Parts Change Information

SUBJECT: ADF Modifications; GR1700 & GR1750 **Document No.: 20277**

Summary: ADF parts have been modified in order to improve feeding. Changes are as follows:

The following parts have been changed:

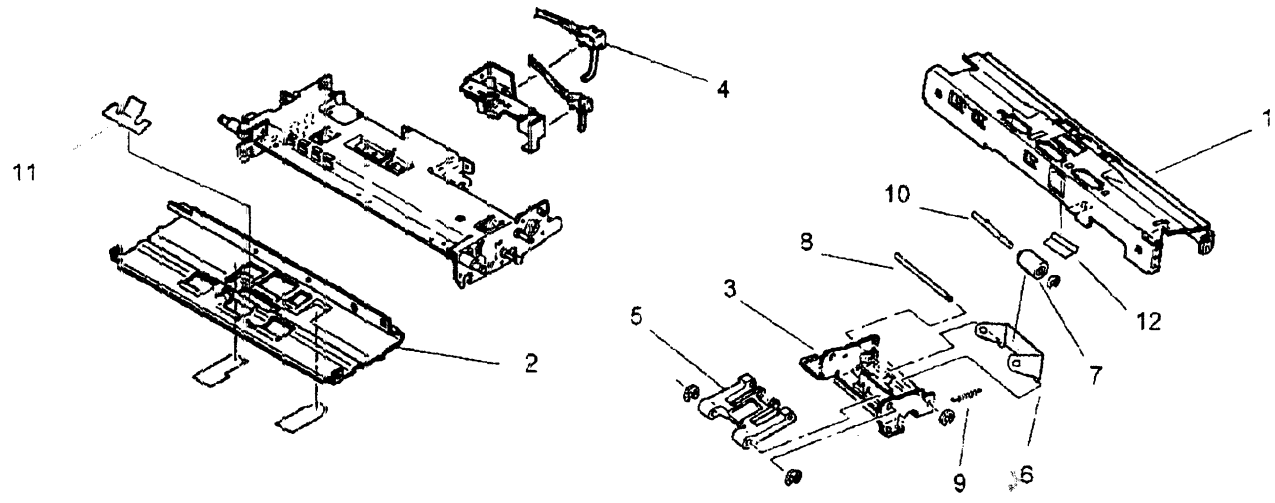
1. The Original Stripper Pad is replaced with a roller-type stripper.
2. Guide Sheets are added to prevent the lead edge of original from braking.
3. The shape of the Original Guide Plates were changed.
4. The shape of the actuator on the Original Det. Sensor was changed.

No.	Name	Present Part No.	New Part No.
	Unit/ADF	**017-96000-208**	**017-96000-305**
1.	Original Guide Base (F); ADF	017-16501-201	017-16501-309
2.	Original Guide (F); ADF	017-16507-501	017-16507-609
3.	Frame B; Original Guide	017-16508-109	017-16508-206
4.	Original Det. Sensor	017-16575-000	017-16575-108
5.	Pickup Arm; ADF	017-16511-002	017-16616-009
6.	Stripper Arm; ADF	017-16512-106	017-16617-005
7.	Stripper Roller; FB-ADF	017-16539-101	019-36536-006
8.	Shaft; Stripper Arm	017-16544-105	017-16618-001
9.	Spring A; Stripper Arm	017-16548-003	017-16619-008
10.	Shaft; Stripper Roller		017-16620-006
11.	Guide Sheet C; ADF		017-16621-002
12.	Guide Sheet P; ADF		017-16622-009
